Bromley - Tweedy Road
Development Report
HolderMathiasarchitects

Previous planning application and inspectors report

Comments from the inspectors report

CGI provided by Proctor Matthews Architects

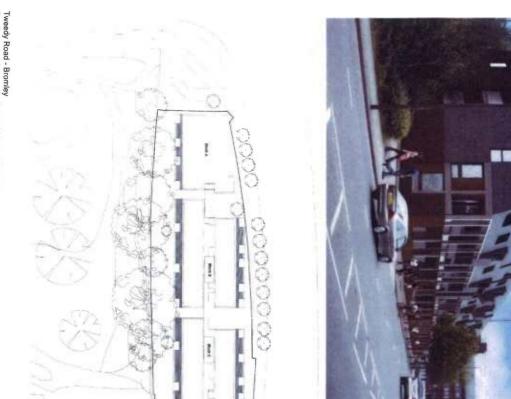
Overdevelopment of the site

elevation was raised as was the hard relationship landscaping to ease the interstitial space scheme offered little opportunity for effective with the pavement. It was remarked that the excessive in bulk and size. The lack of relief in The inspector believed that the 72 unit scheme was

N Harmful to the adjacent conservation area and listed buildings

The relationship of the proposed building and the grade II listed building perpendicular to the site was poorly considered. In particular there were proposed development and Sheppards College concerns regarding overlooking between the Views from the north from tweedy road were also

Harmful to the amenities of the occupiers of Bromley and Sheppards Coleges

The inspector did not believe that the scale of the building had too detrimental effect on the amenity of the adjacent listed buildings.

Site Plan by Proctor Matthews Architects

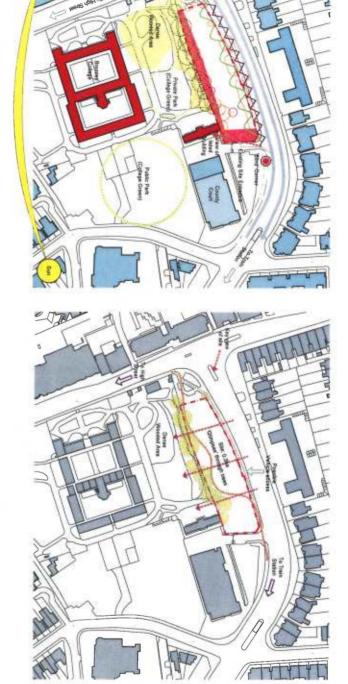
Poor quality amenity space

buildings and tress surrounding it. The shared garden was seen to be long, narrow and hemmed in which would provide restricted daylight due to its location and the mass of the

Appearance and Character

no views through the site towards the conservation appearence of the scheme. The design also offered was unconvinced by the 'out of character' area which was seen as a dissapointment Further to the issues of bulk and size the inspector

Parking provision

The inspector believed that the parking provided was sufficient for such a site. The scheme provided parking for 47% of units.

A buffer must be provided at the south of the site in order to protect the privacy of surrounding spaces and allow the preservation of existing, mature trees.

Views through the development must be provided to maintain a connection with the wooded area to the south

An access point to the site should be introduced in order to elevate congestion at the existing site entrance which is a blind turning.

Some relief to the site boundary line must be introduced in order to avoid a dense linear sightline along Tweedy Road.

Overlooking between the new building and the existing listed building should be respected. No oblique views within 15m of the northern most window should be created.

No direct overlooking within 21m will be acceptable.
